AFRRI TR83-1

**Safety analysis of modifications
to upgrade the reactor ventilation
system at Armed Forces
Radiobiology Research Institute**

REQUESTED ADMINISTRATIVE CHANGES

Figure 2. Diagram of ventilation system. (This figure will replace Figure 3-5 in the Safety Analysis Report and Figure 4-1 in the Reactor Operations Manual.)

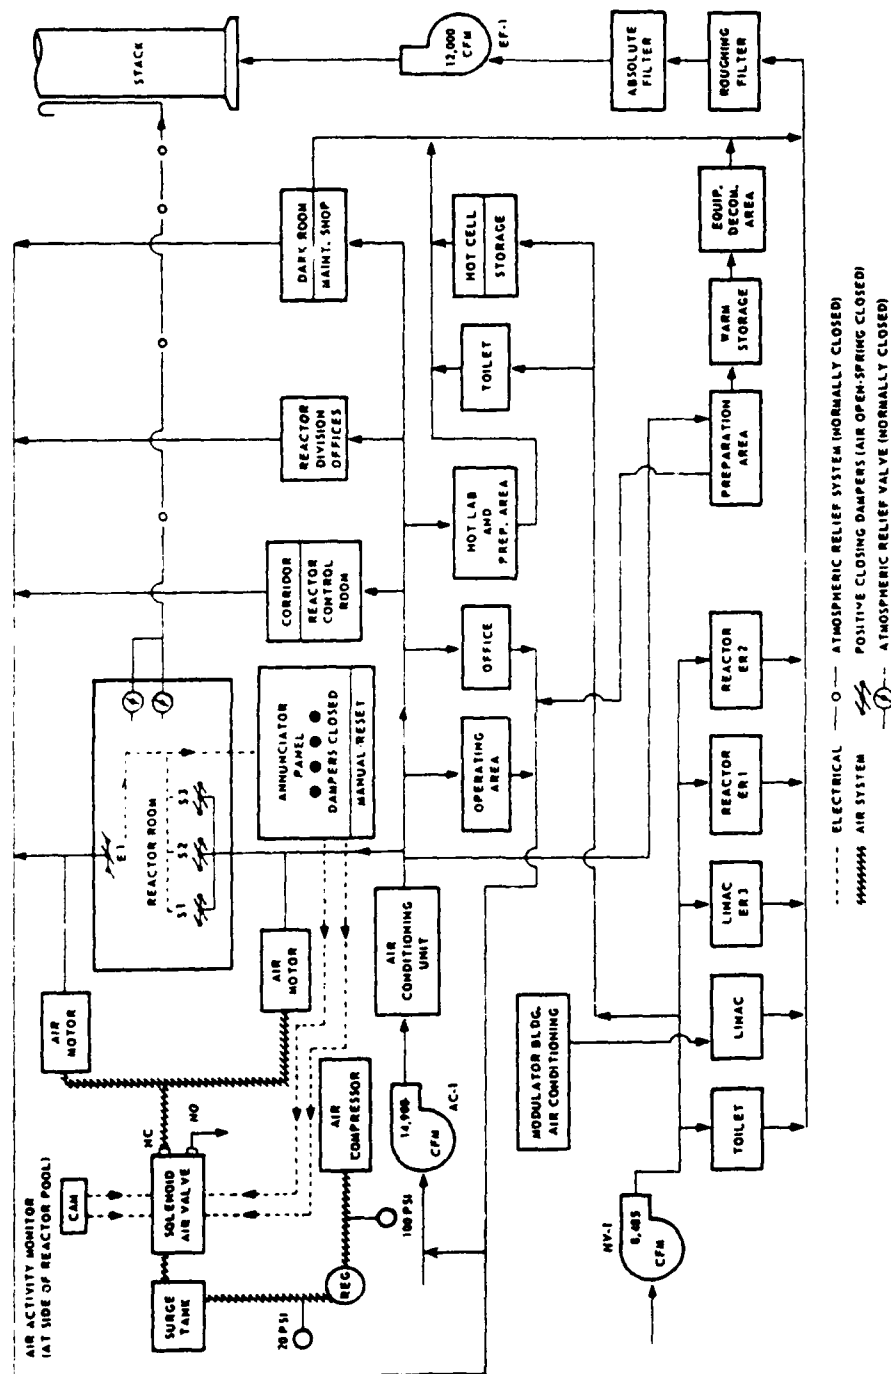
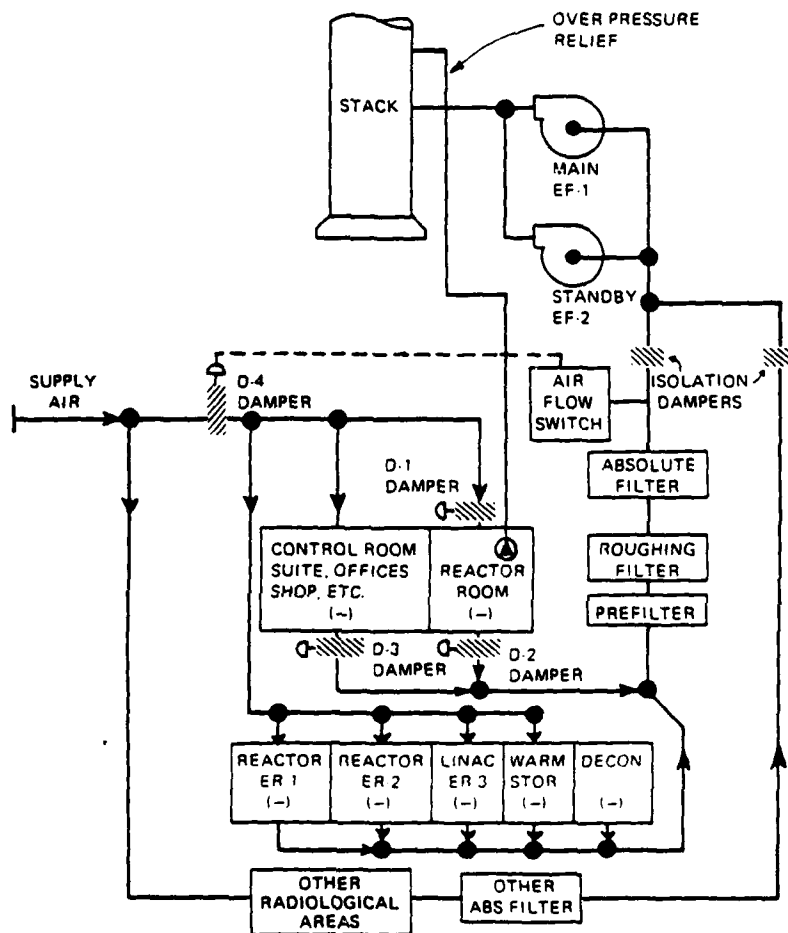
At present, AFRRI consists of five phases, or separate building units; each phase has its own ventilation system, which is independent of the reactor's ventilation system. Complications associated with the growth of the AFRRI complex require certain changes to be made in the AFRRI ventilation systems. It has been proposed that a centralized system designed to serve the entire AFRRI complex will replace the separate systems, which require constant adjustment and maintenance. The system servicing the reactor areas would become a separate branch of the AFRRI system; along with other branches having radiological significance, the reactor branch would receive special air treatment. Several improvements in the air system and in the manner in which it performs its intended functions would increase the safety relating to possible airborne radioactive contaminants from the reactor and reactor operations. The proposed air system is shown in Figure 2.

Comparison of the present and the proposed air systems shows that major improvements to the system will be made without major changes in either design or function of the system components described in AFRRI administrative documents.

The relative differences between the two systems are explained below, as well as the advantages of the proposed air system over the present one:

Figure 3. Changes to Figure 3-5 in the Safety Analysis Report. Change 1: Single-pass air system for reactor area. Change 1A: Air supply for reactor area building.

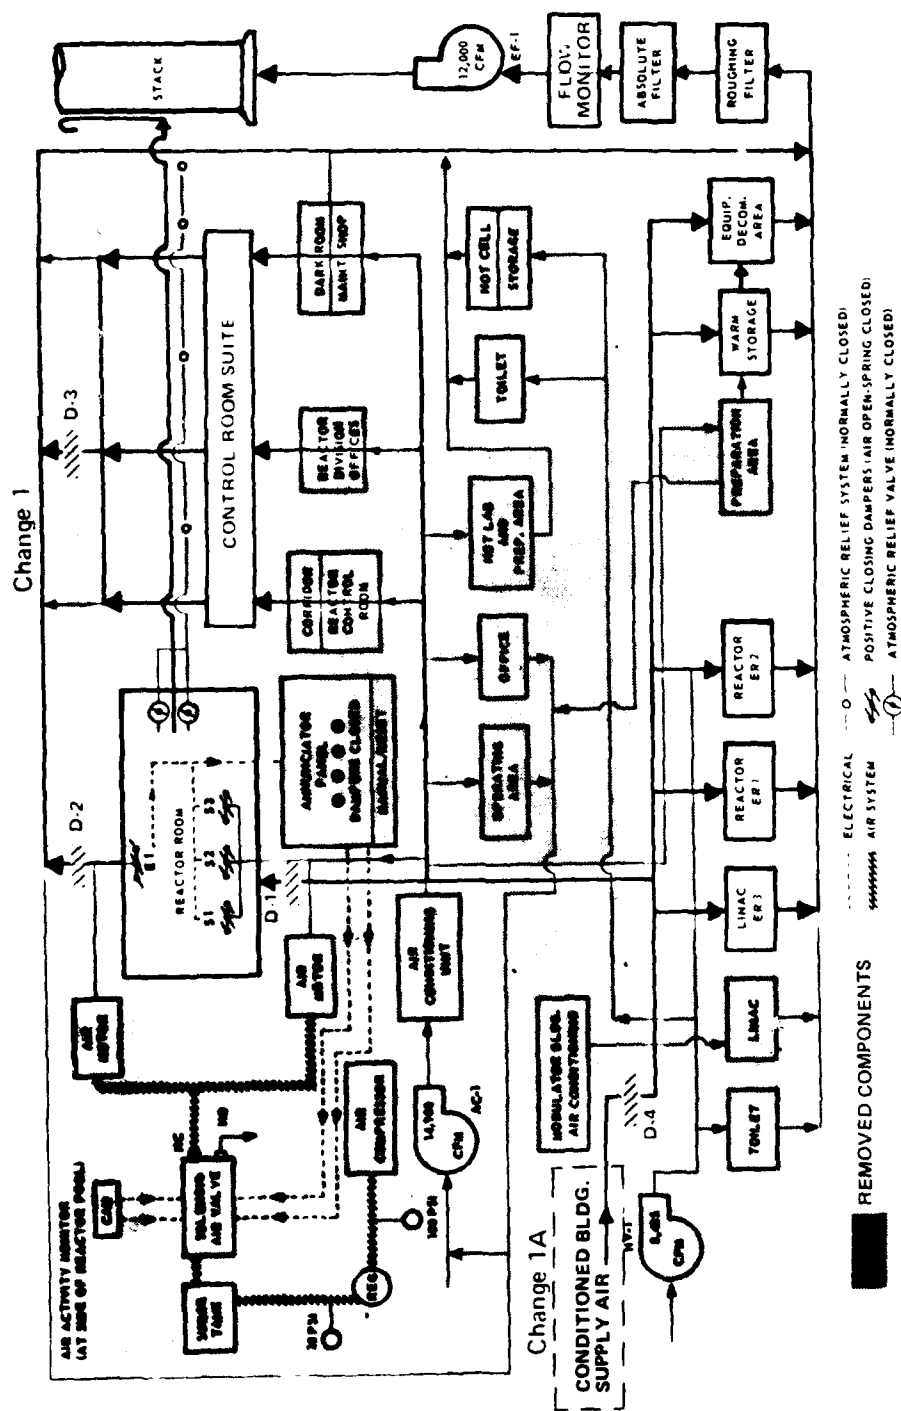
1. 100% Exhaust Air Versus Recirculation Air: The current air system uses recirculated air mixed with outside air in most of the reactor building, except in the exposure rooms (ER's), the restroom on the lower level, and the hot cell. These areas exhaust 100% of their air. The reactor room air ducts use dampers to provide isolation in case of an airborne problem. The upgraded system is more safe radiologically because all air in the reactor-related areas is 100% exhausted. In addition, the air in the reactor room is held at a negative pressure in relation to the control room suite, which is in turn held negative in relation to the rest of the AFRRI complex. This is shown as change 1 on Figure 3.

3. Supply Air: In the existing system, air is supplied to the reactor building from two air-handling units. A heating and ventilation unit supplies 100% outside air to the exposure rooms, the hot cell, and a restroom on the lower level. Air from these areas is exhausted thru the radiation stack. The other air-handling unit mixes outside air with recirculated building air, and supplies it to the rest of the reactor building. In the proposed system, the reactor branch will receive supply air that is filtered and conditioned to standard laboratory quality. See change 1A on Figure 3.

Figure 4. Change 2 to Figure 3-5 in the Safety Analysis Report: Reactor building areas removed from system

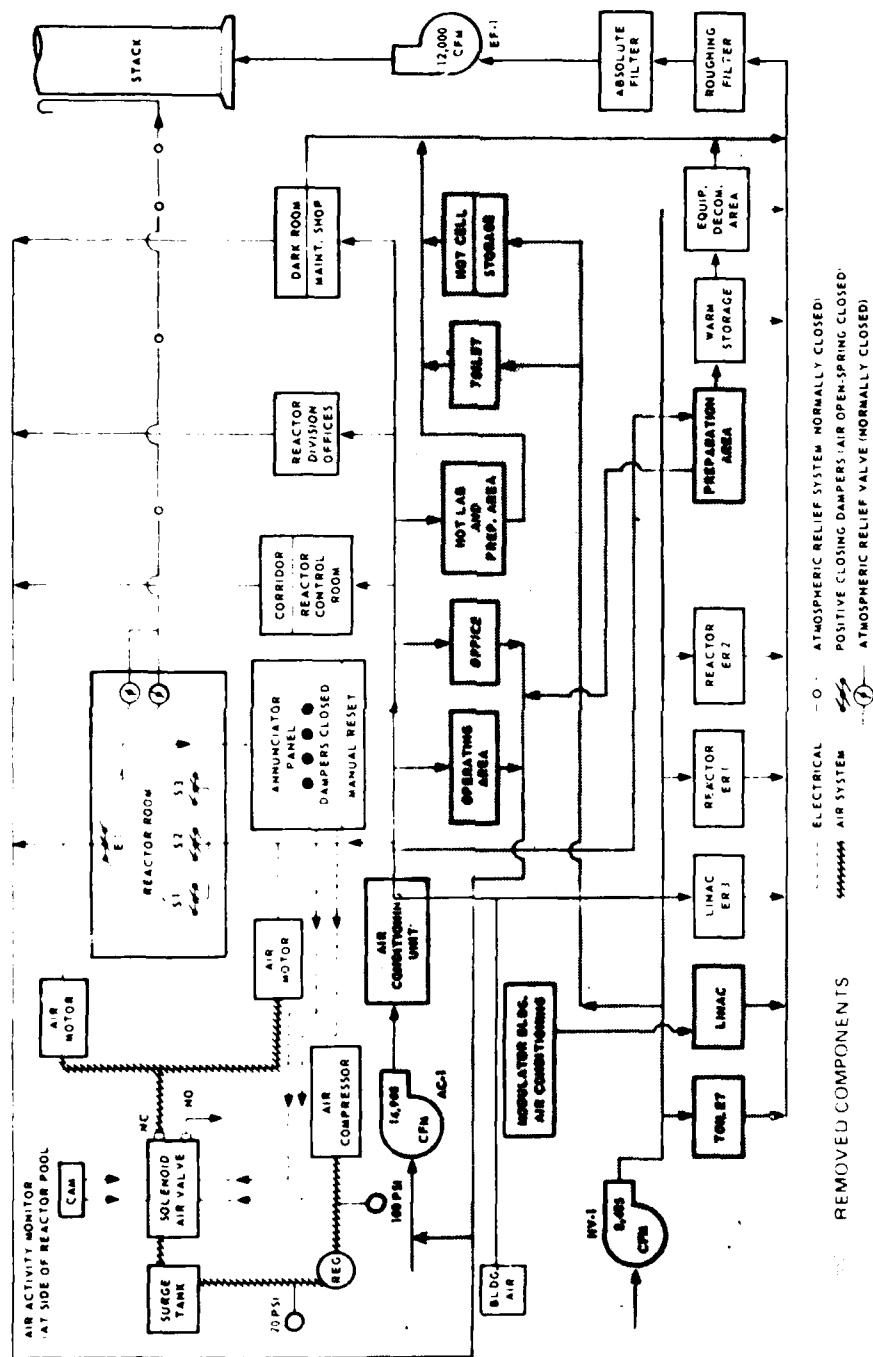
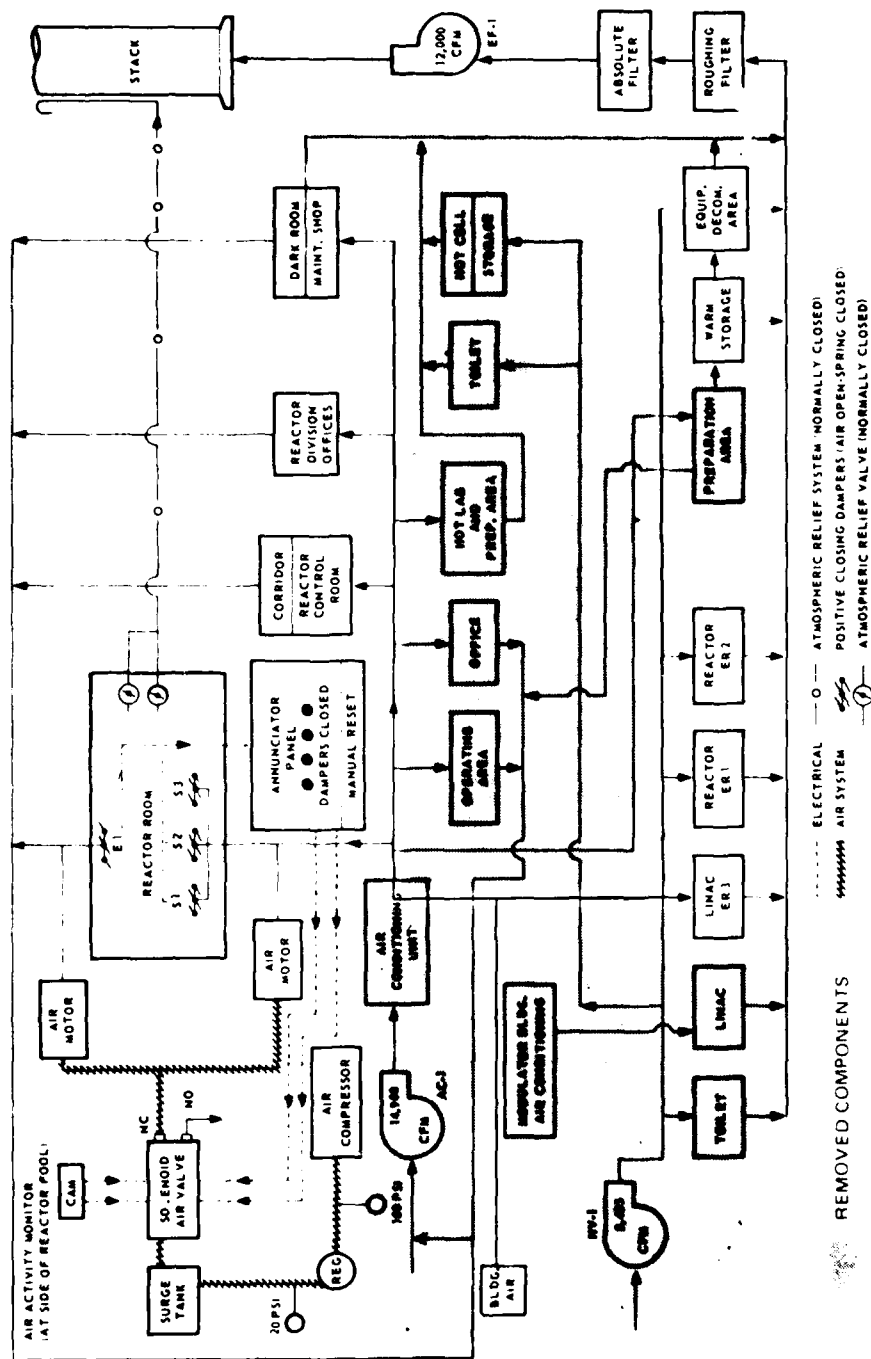
2. Areas Excluded From the System: When the current system was installed, certain areas were included in the reactor air system because they were located in the reactor building. However, these areas are not of direct concern to the reactor-related operations, and have been excluded from our realm of consideration. Areas having radiological significance not related to the reactor are considered as other branches having special radiological treatment. The changes are shown in Figure 4.

Fig. 3-5A Schematic Air Flow Diagram

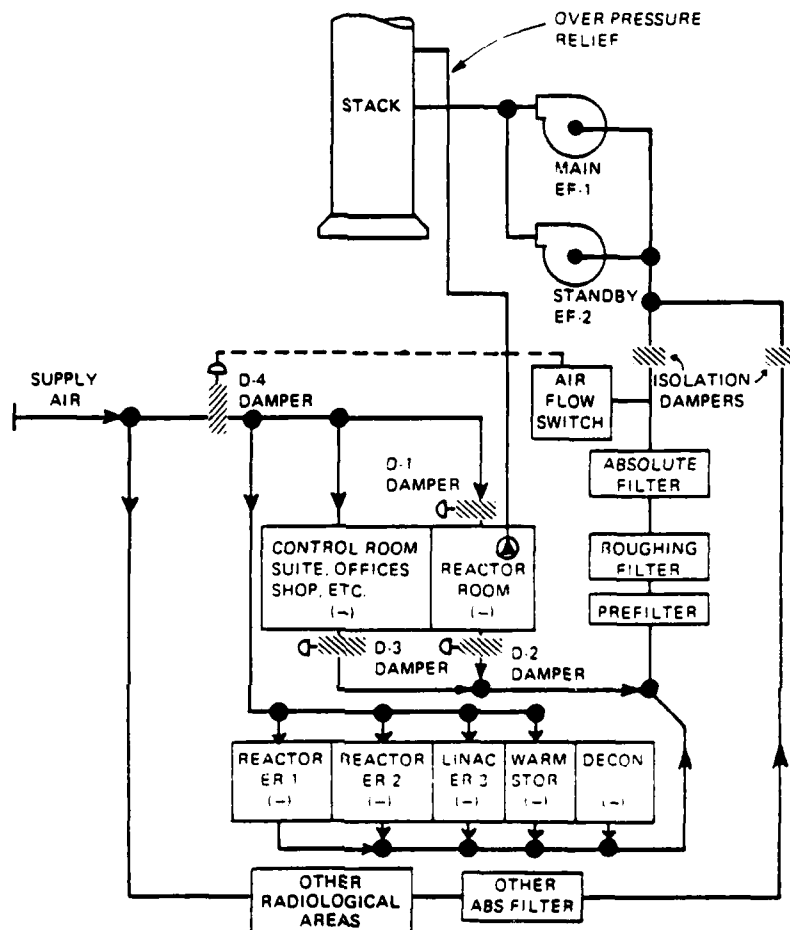
Replace figure 3-5 with inclosed figure 3-5A.

Change 4: Remove Figure 3-5; insert new Figure 3-5 (Enclosure 9).
